**Friends of Griffith Park**

June 18, 2018

RE: CF 18-0057 – Griffith Park Mobility and Access

# Proposed Access to the Hollyridge Trail from Beachwood Drive

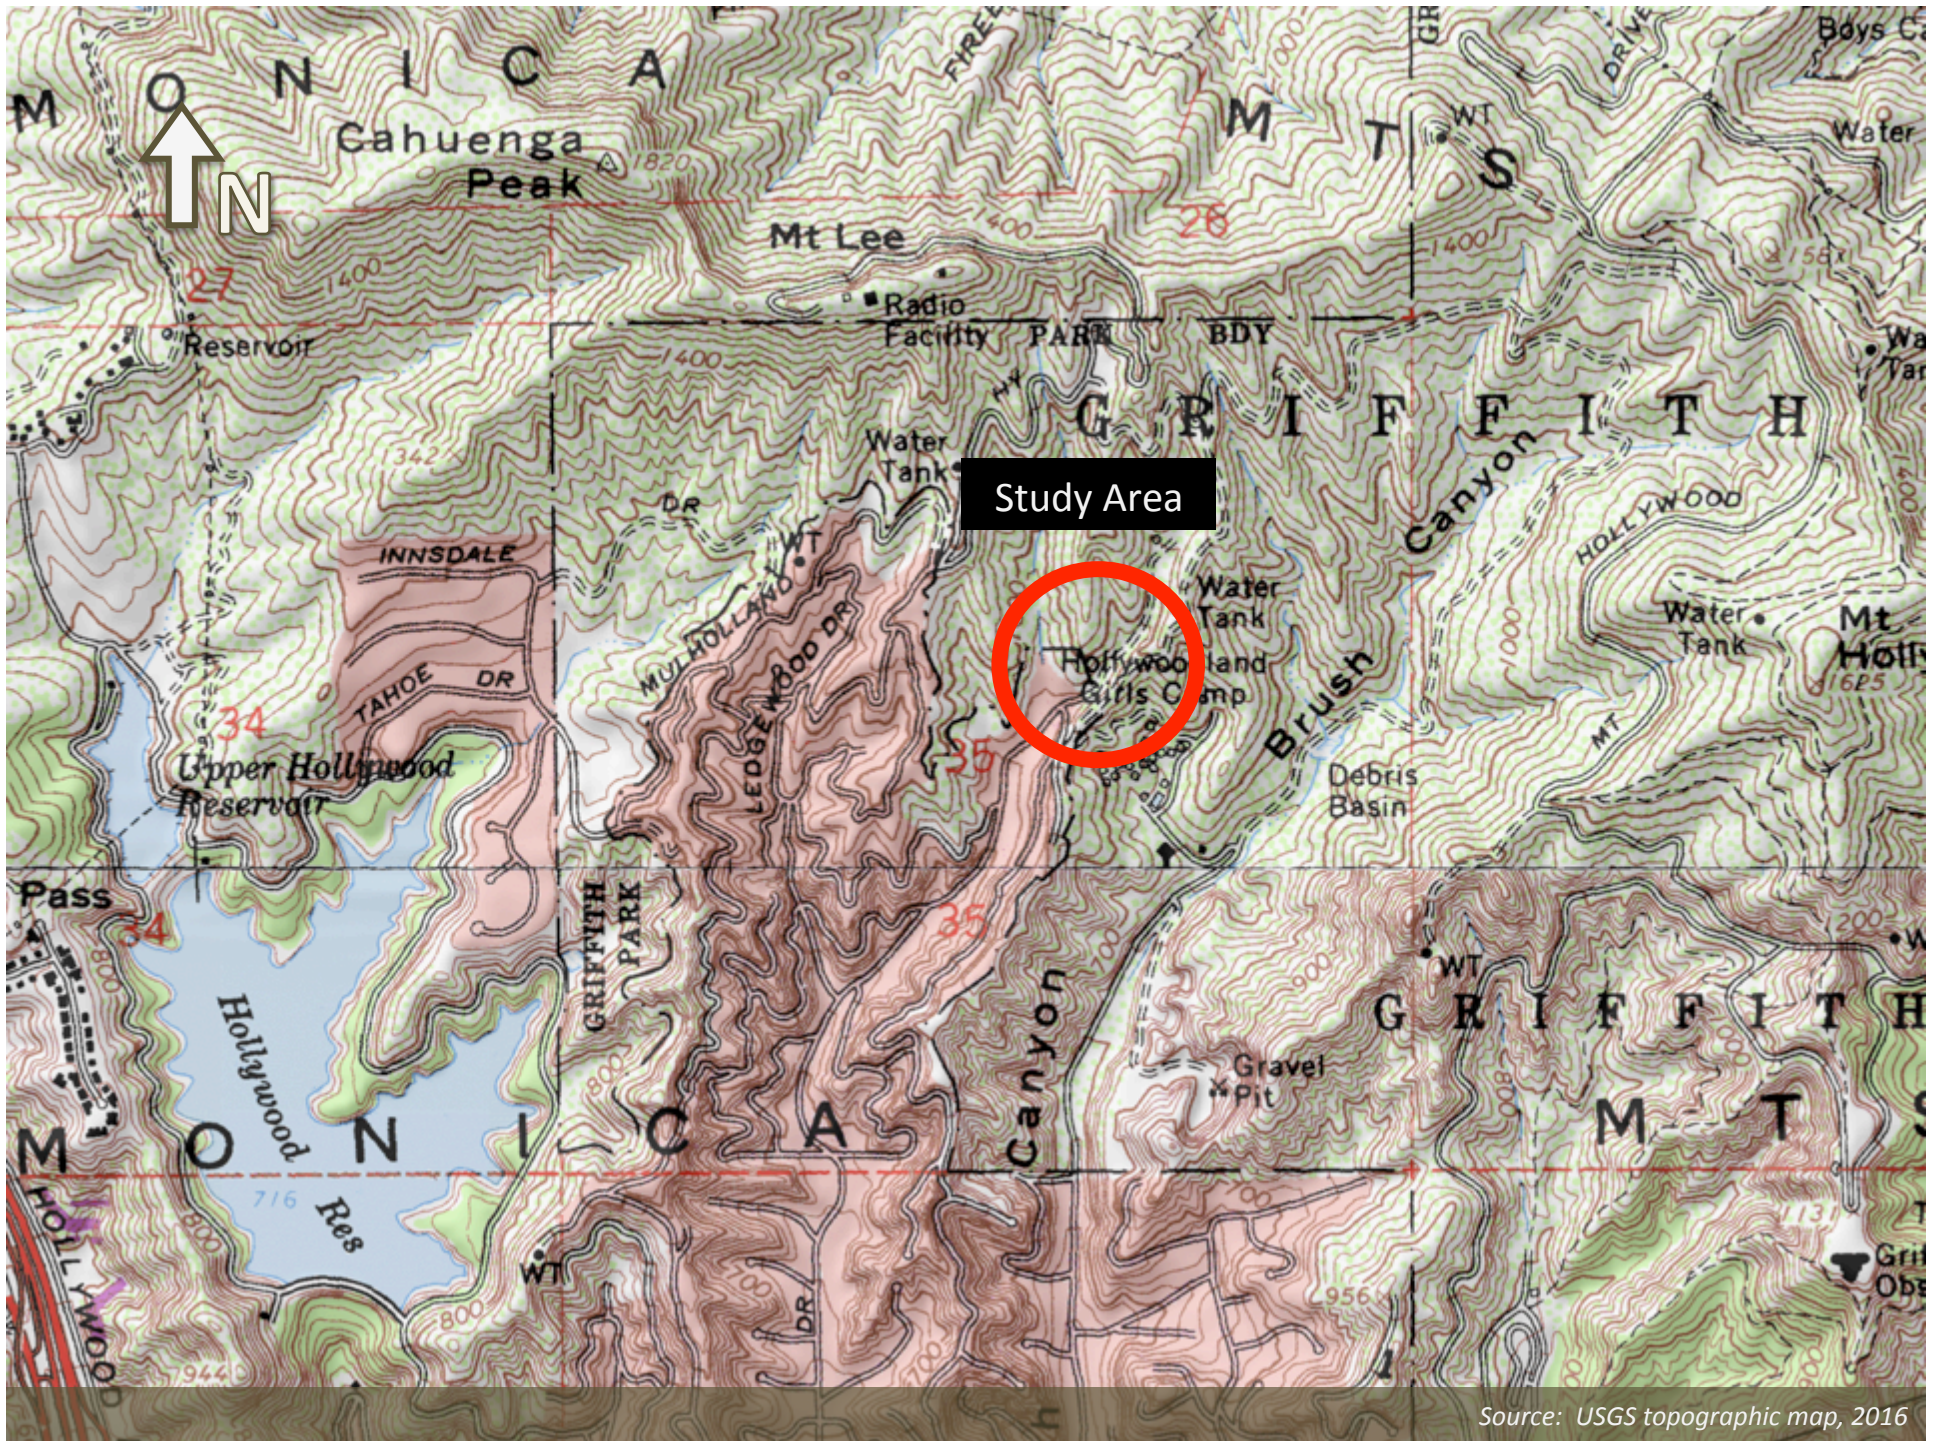
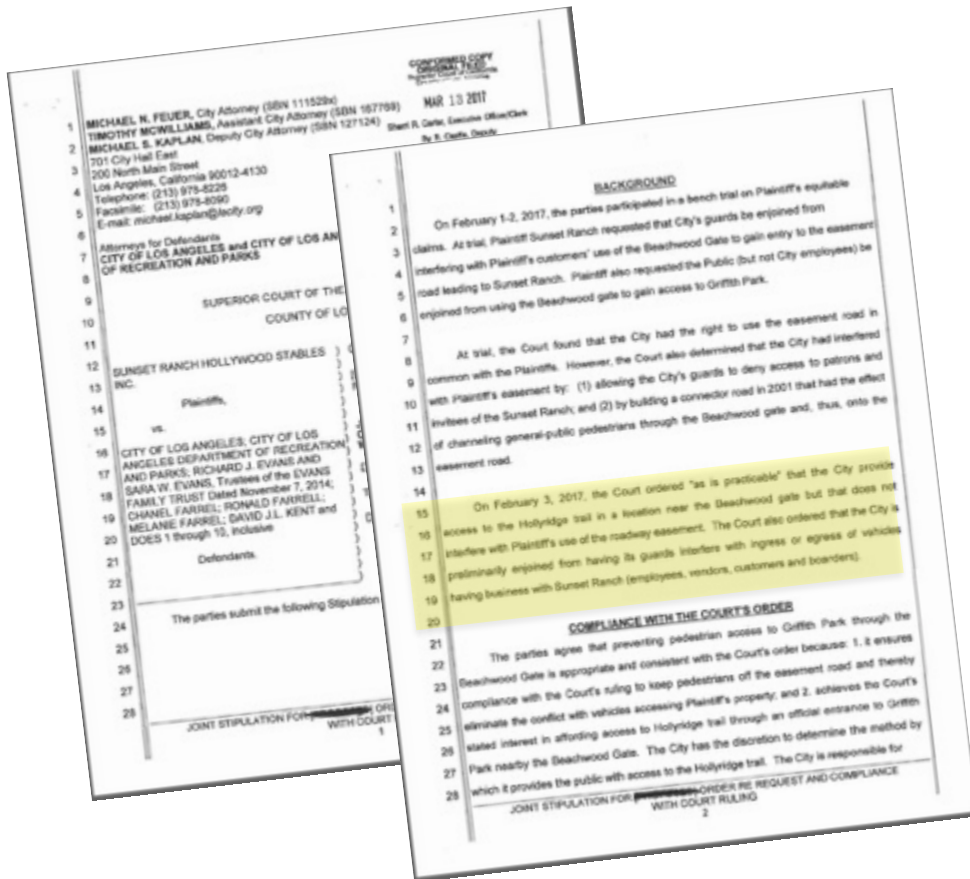
4. The preferred plan is the one which was highly circulated in June 2017. It includes modular steps or switchback trail which would direct hikers up a 50-foot vertical rise from the existing entrance’s east side fence to the old Hollyridge Trail. This plan is simple and would shield sensitive habitat from impacts. See attached, as this specific plan should be reconsidered by the pertinent city departments.

Court Order from Feb. 3rd, 2017 directing the City to provide access to the Hollyridge trail near the Beachwood gate

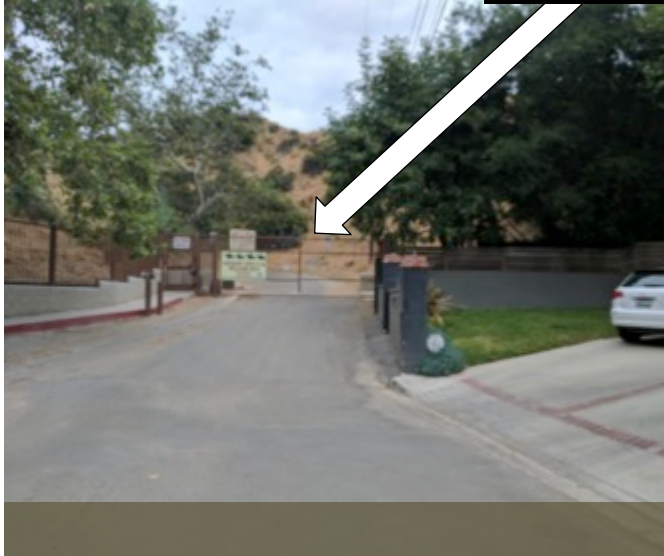
1. The report incorrectly states that, “the Judge instructed the closure” of the gate. To be accurate, the judge enjoined and ordered the City “to provide public pedestrian access to the Hollyridge Trail, at a location as closest to the start of the subject easement...as is practicable.”

Elevation difference from bottom to top of proposed Trail access, as estimated from USGS topographic maps and Google Earth data

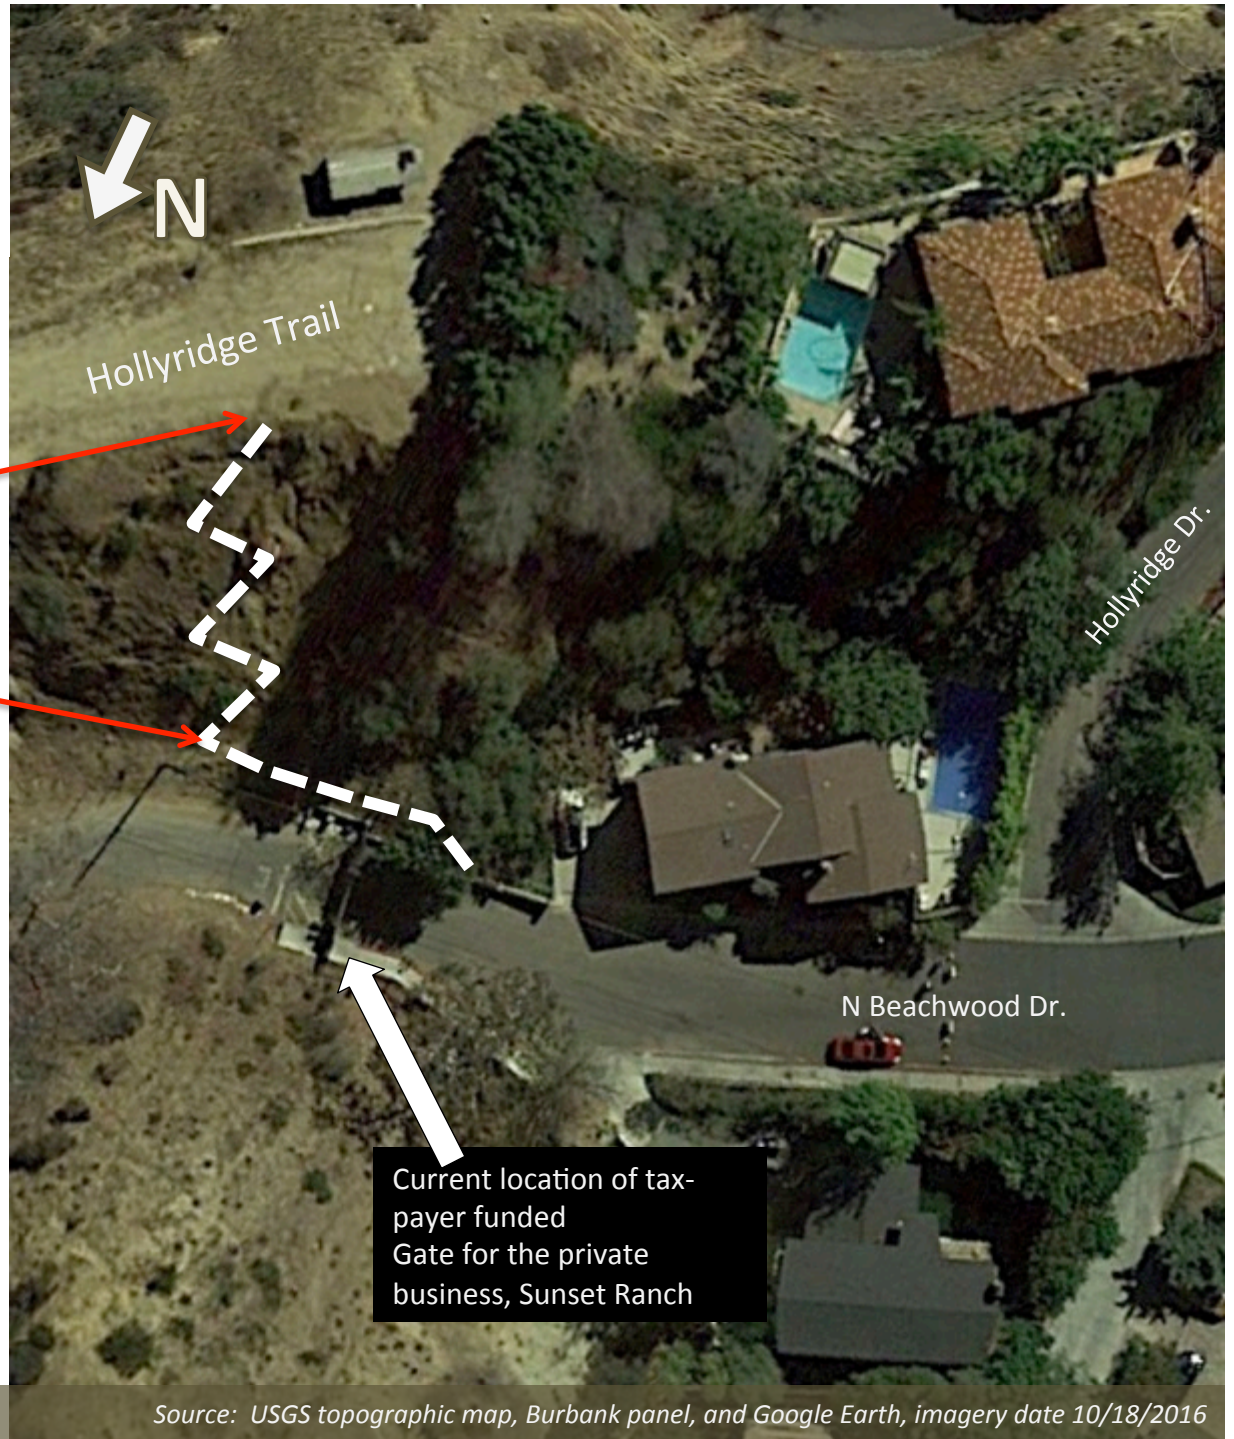
Overall elevation change: 50'
